CONTAMINATION ASSESSMENT REPORT ADDENDUM WITH TRANSMITTAL FOR SITE
1122 OUTLYING LANDING FIELD BRONSON NAS PENSACOLA FL
04/23/1999
NAVY PUBLIC WORKS CENTER

**CONTAMINATION ASSESSMENT REPORT ADDENDUM
SITE 1122, U.S. NAVY OUTLYING LANDING FIELD (OLF)
BRONSON FIELD**

RE: CONTAMINATION ASSESSMENT REPORT ADDENDUM (CARA),
U.S. NAVY OUTLYING FIELD (OLF) BRONSON, SITE 1122, PENSACOLA,
FLORIDA

**FIGURE 11: CROSS SECTION OF THE SITE SPECIFIC
STRATIGRAPHY**

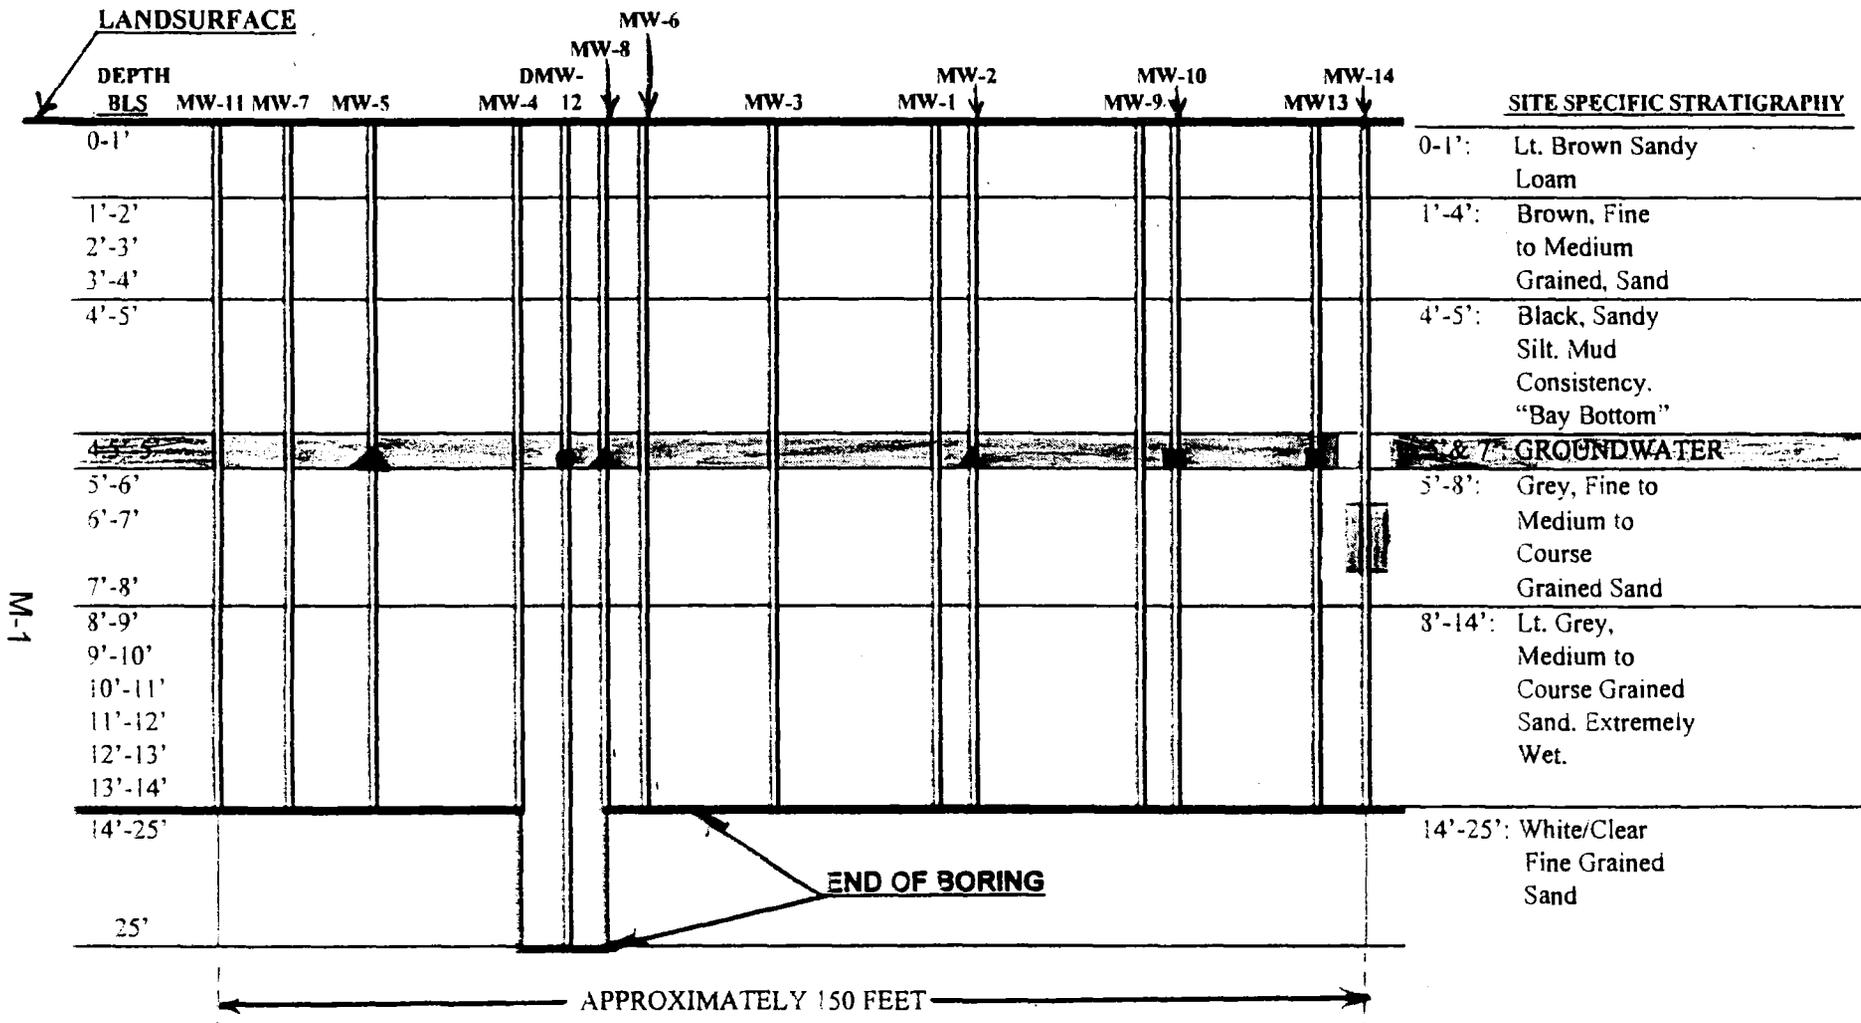
- (i) A cross section of the site specific stratigraphy. (62-770.600(7)(a)16.)
 - (j) Site map showing all soil sampling locations in relation to former tanks, lines, dispensers and excavated areas. (62-770.600(7)(a)19.) This should reveal whether soil borings were appropriately located in the vicinity of the former tanks.

(1)(i) A cross section of the site specific stratigraphy is included in Appendix M, Figure 11. The cross section shows the approximate location of monitoring wells MW-1 thru MW-14, the depth of well, the general lithology of the site and the location of chemicals of concern as they were detected in the June 4, 1996, and August 23, 1996, sampling events. No VOCs were detected in the soil samples collected from boreholes SB-1 thru SB-13 or the boreholes from monitoring wells MW-1 thru MW-14.
